From: Northern Comfort <managers@northerncomfortllc.com>
Sent: Thursday, September 01, 2016 11:33 AM
To: Mary O'Neil
Cc: 'Chris Alley'
Subject: RE: Materials, meters, mailboxes

From: Mary O'Neil [mailto:MCOneil@burlingtonvt.gov]
Sent: Thursday, September 01, 2016 11:15 AM
To: Chris Alley; managers@northerncomfortllc.com
Subject: Materials, meters, mailboxes

From: Northern Comfort <managers@northerncomfortllc.com>
Sent: Wednesday, August 31, 2016 10:18 PM
To: Mary O'Neil
Cc: 'Chris Alley'
Subject: Rose Street Questions

Design House Model # 519504 ★★★★★ (18)

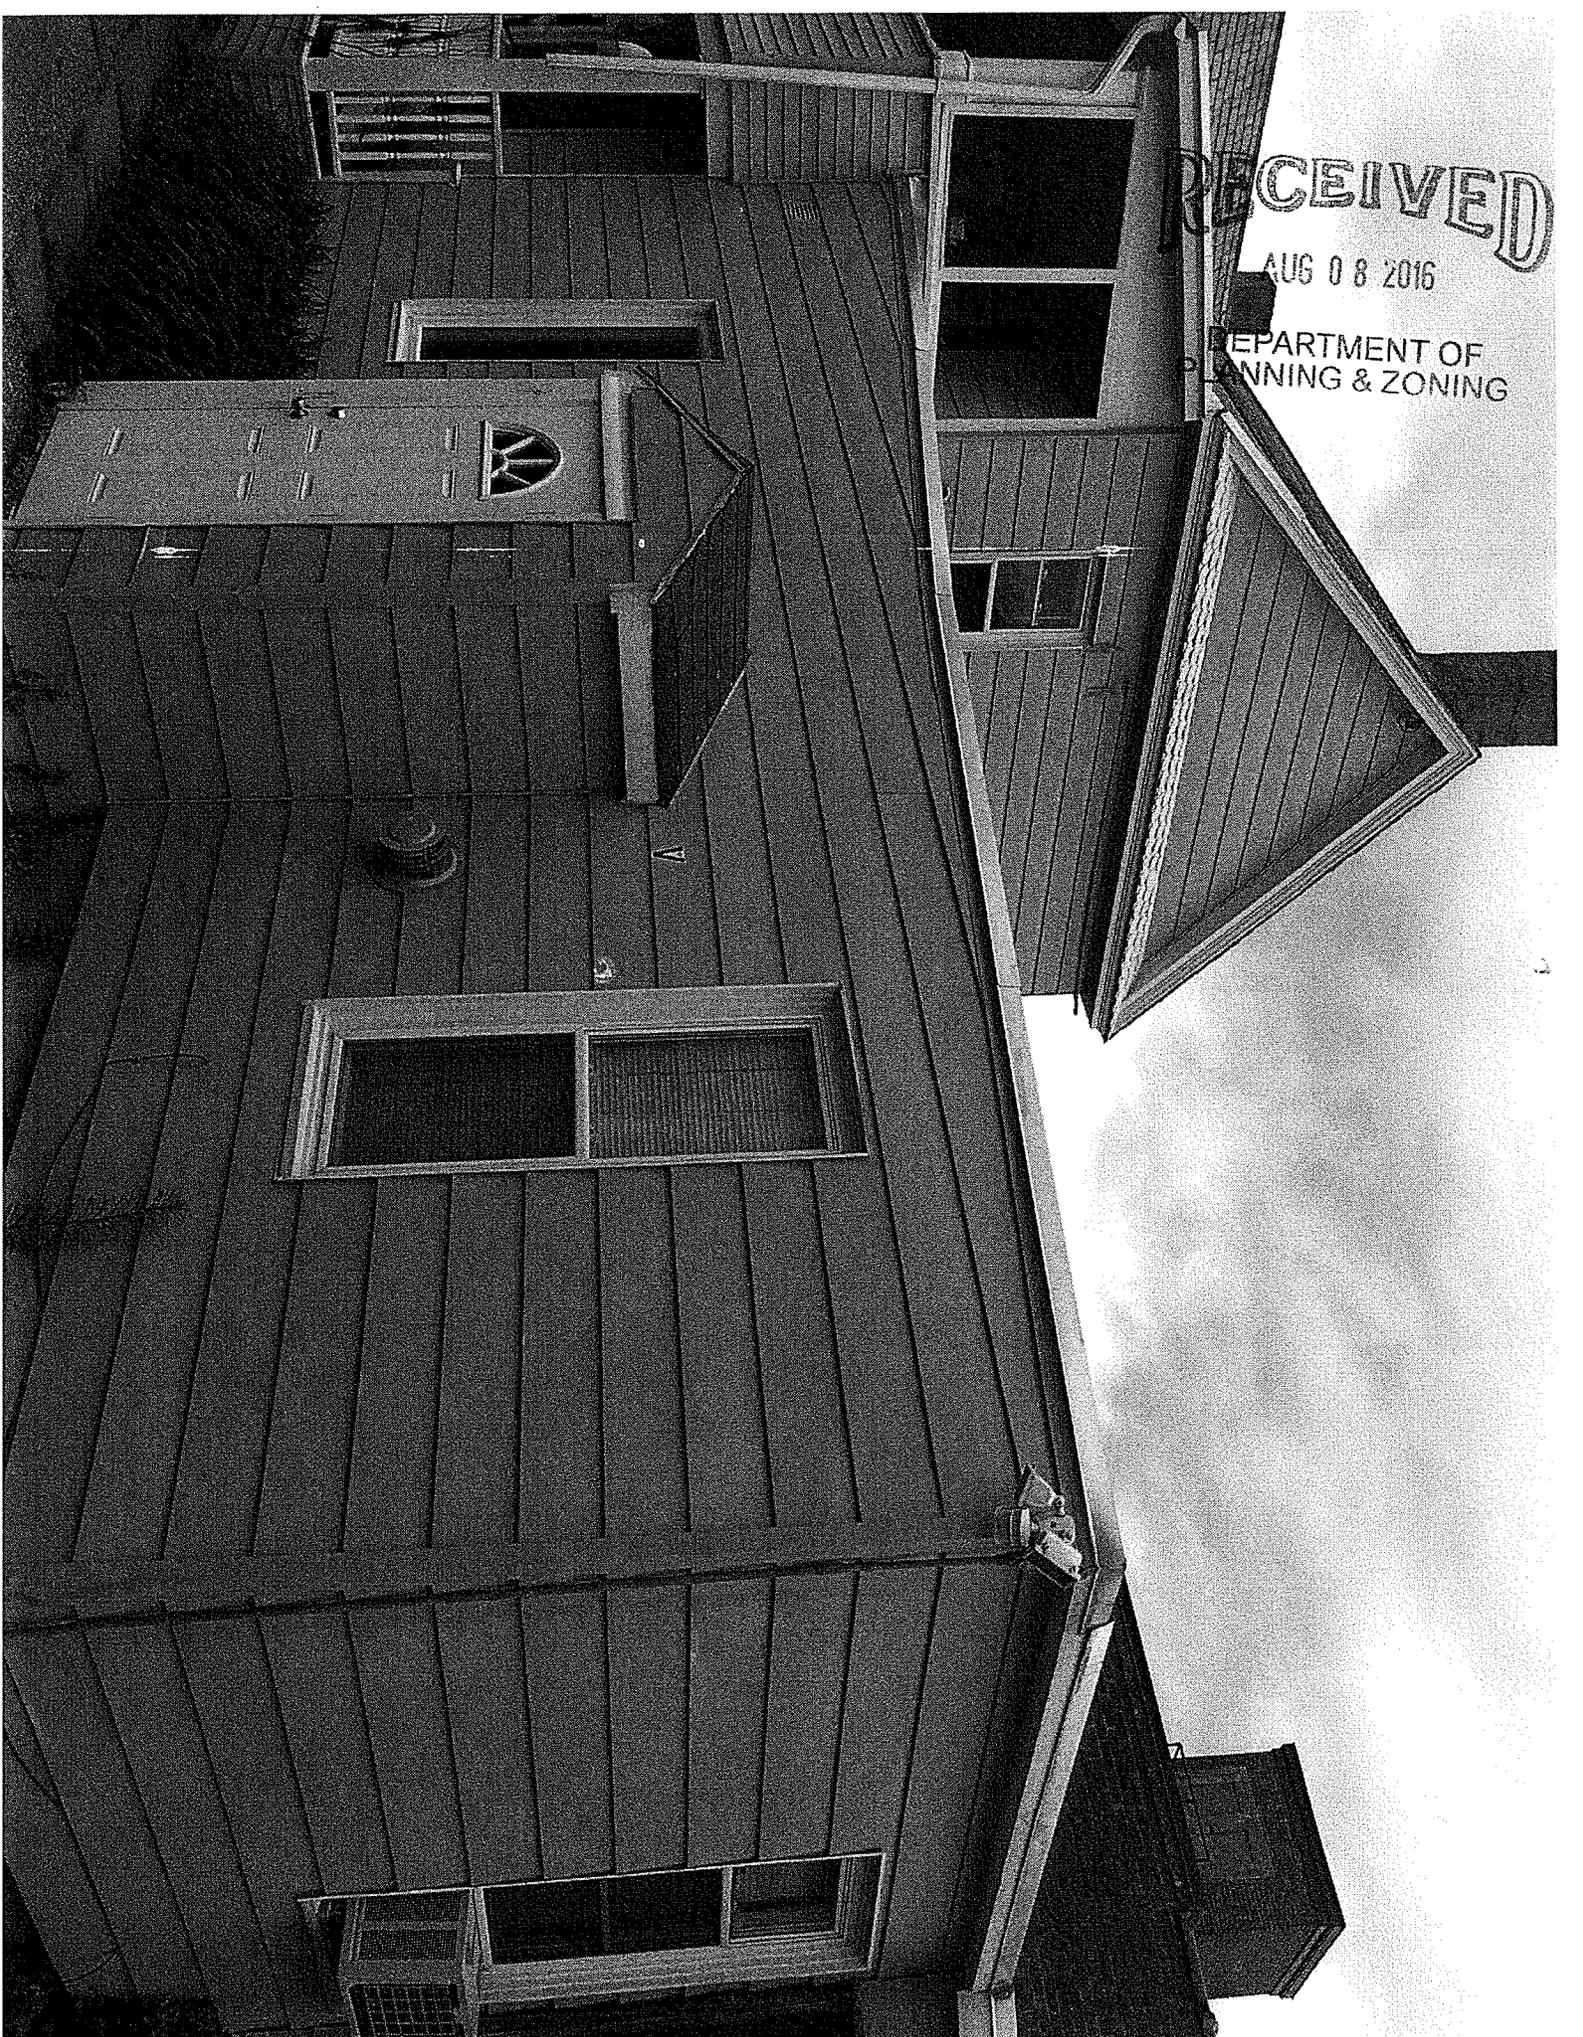
For the exterior porch light, we were thinking these....
